WISC eBook Version 4

Version 3 feedbacks

SPE - Wellbore Positioning Technical Section

Figure 16—AI-AMR downhole tool configuration

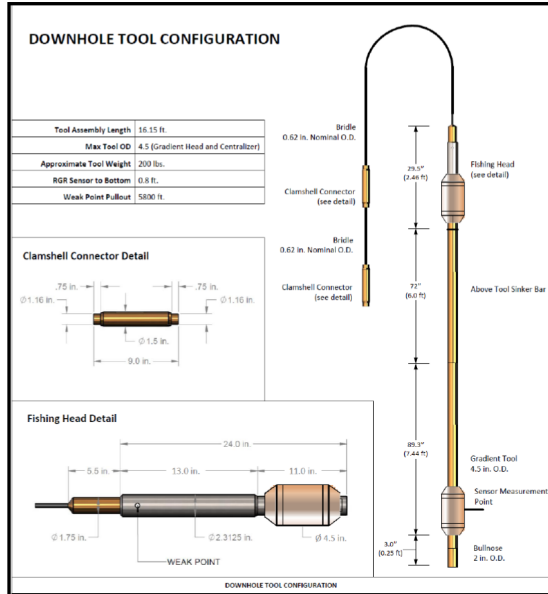
1. Figure 16 is scaled down too small – I have my glasses on, but miss the detail as given in the previous version (Fig. 7) where the diagram is physically larger. **Action HAL**

Figure 43—Illustration of PMR and AMR incident angle

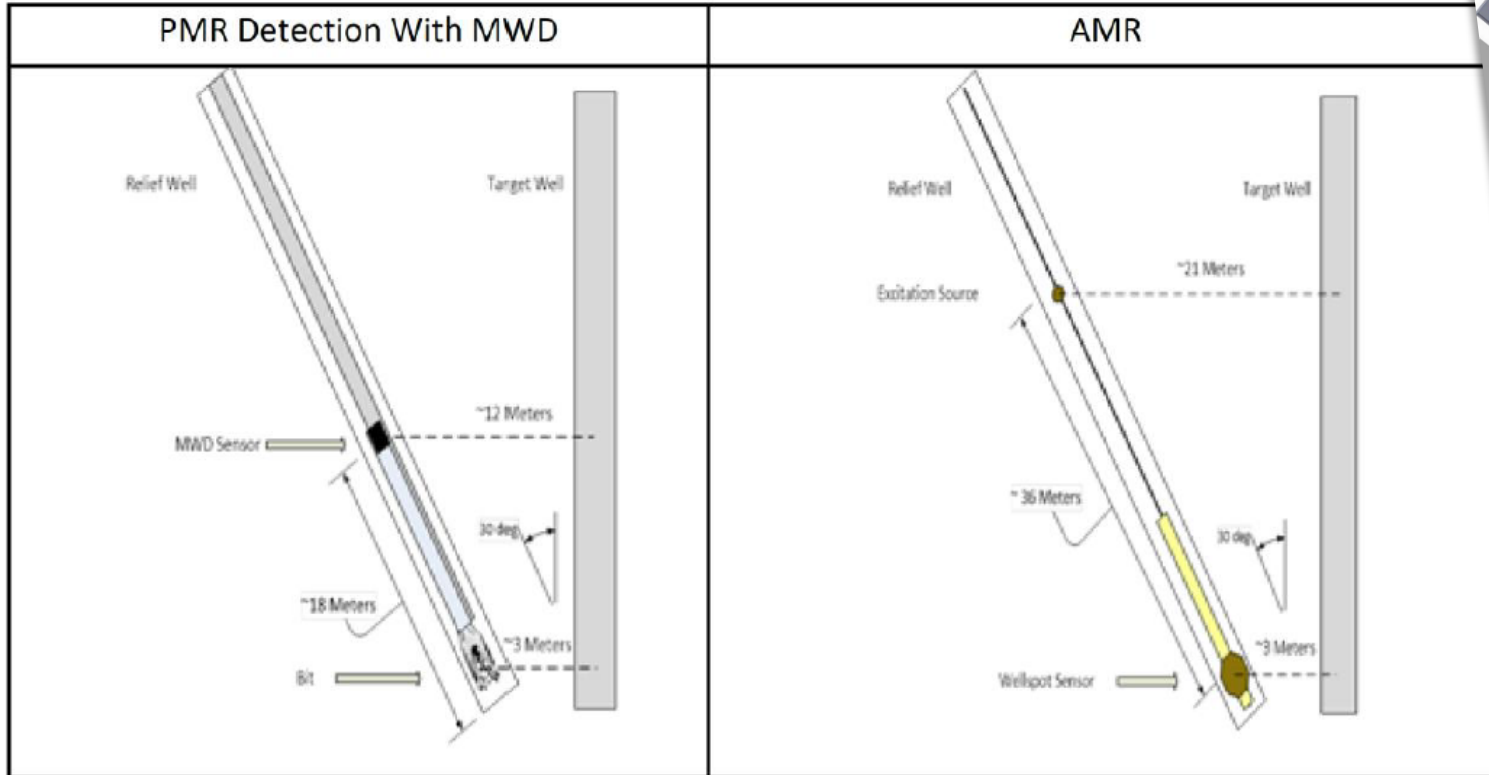
5. Section 7.2.1 & 7.2.2: how true/untrue is the values of 12m and 3m ? Surely this is heavily dependent on equipment specification and angle of incidence ? Maybe a comparison of vendor tool performance/specifications would be useful here ??

Action; John, Nich, Benny

Figure 49—Various examples of relief well designs

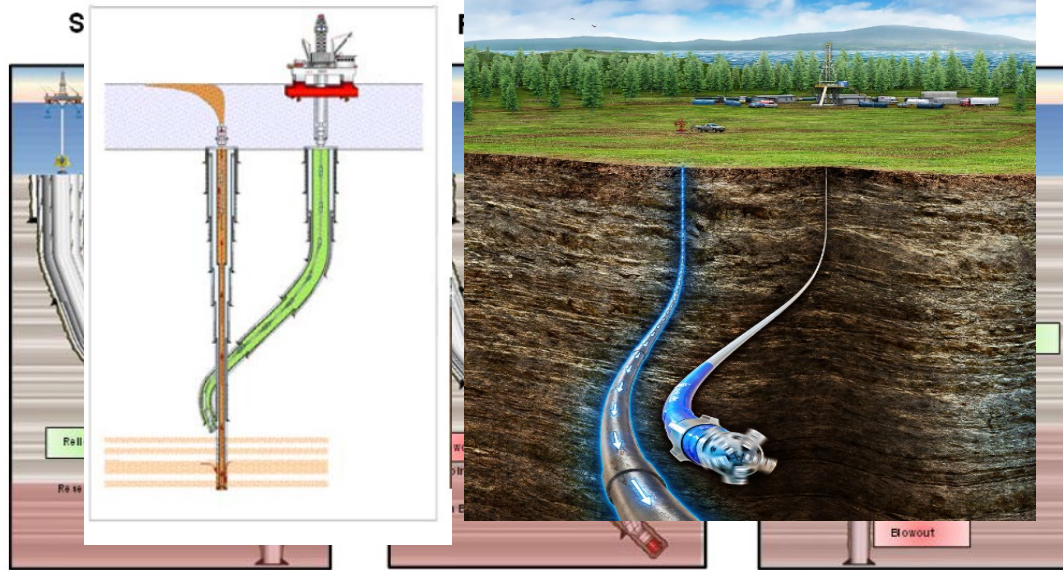
6. Figure 49 is somewhat unclear. It may be worth recreating the image so that the text elements are legible. **Re-drawn ?**

Action; Jamie

Figure 55 —Surface Location and Drilling Complexity Sensitivity Analysis

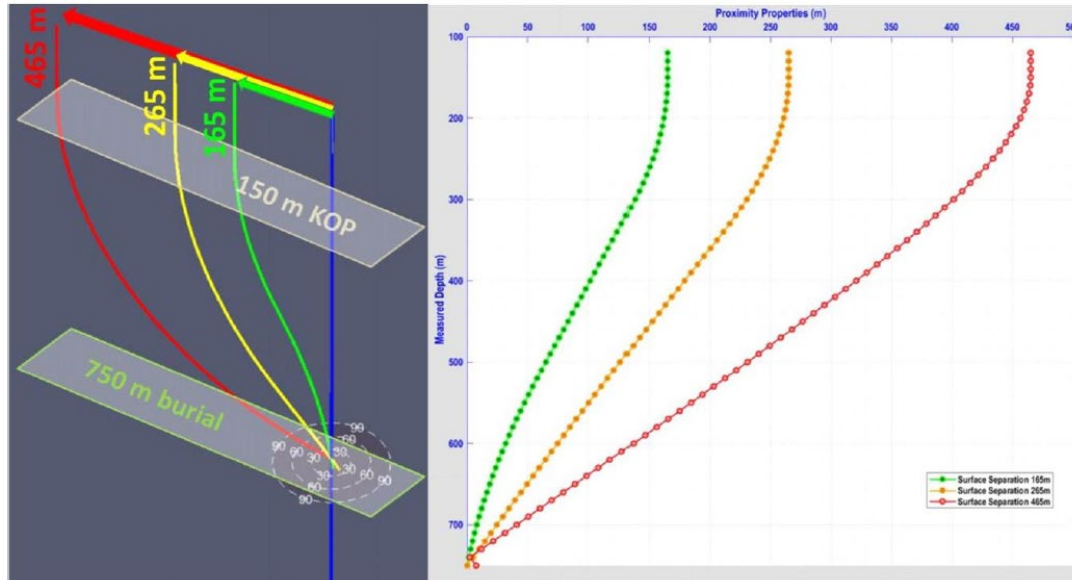
7. Figure 55 is difficult to read the axis and color legend box.

Action; Benny

Figure 82—A typical example of relief well trajectory in GOM

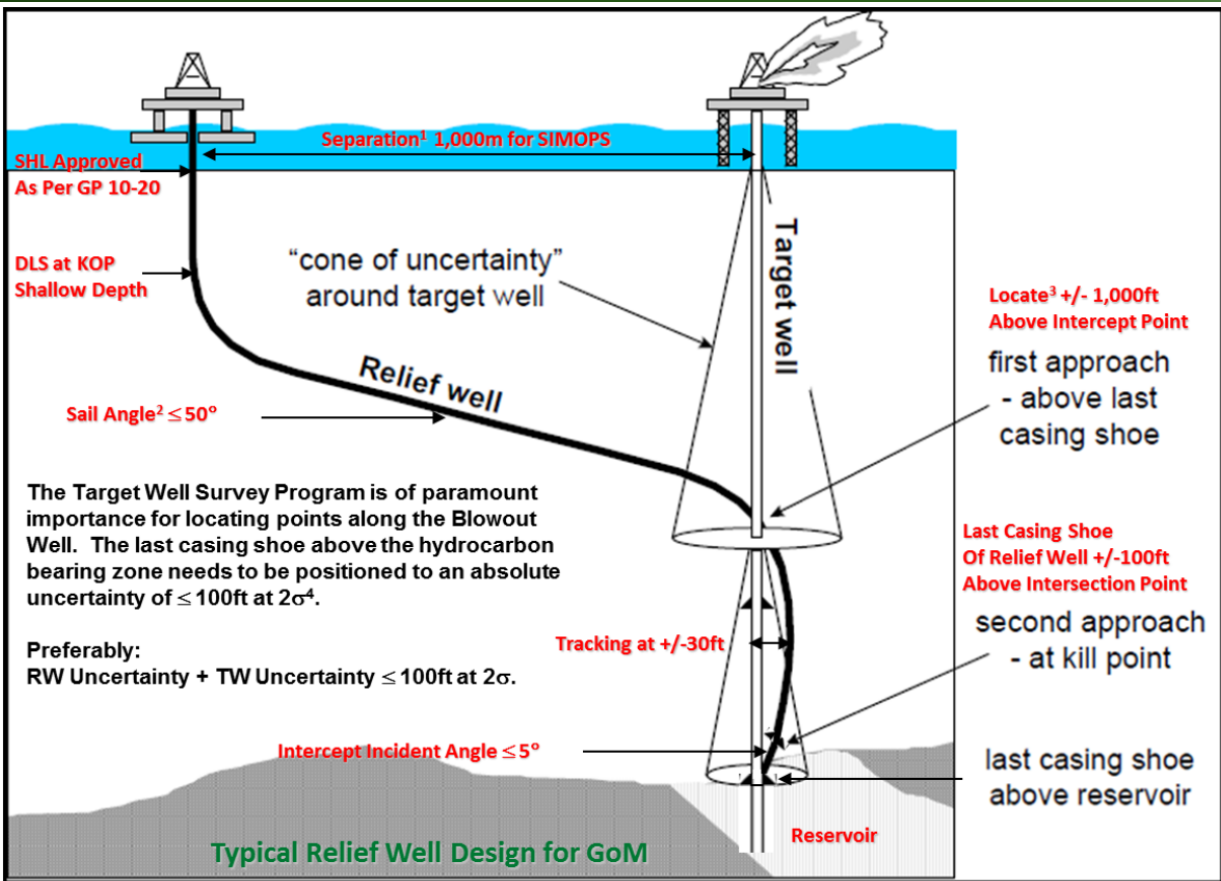
8. Fig. 82 needs a little more explanation – I believe that this is a critical diagram. You know my views on 3-d uncertainty determination and depiction – the diagram assumes a “cone of uncertainty”, and refers to $< +/-100$ ft for the position of the casing shoe above the reservoir. The diagram illustrates GOM, and so we may assume 15k – 20k ft well depth. This gives an AHD accuracy of $< +/- 100/20k = <0.5\%$ for AHD (ignoring Az & Inc.) which is the limit of what is achievable using strapped pipe and no correction. It is important to mention this (in my opinion) because it sets that standard for AHD accuracy that might be applicable. (Lucky drillers ! If so, they don't have to do anything different and SLB can log down !). Now, if anything more accurate than this is needed (?? what does “<” mean ??), THEN specific AHD measurement accuracy specifications have to be taken into consideration in order to achieve the then higher AHD accuracy requirements.

Action: Harald then to Jamie
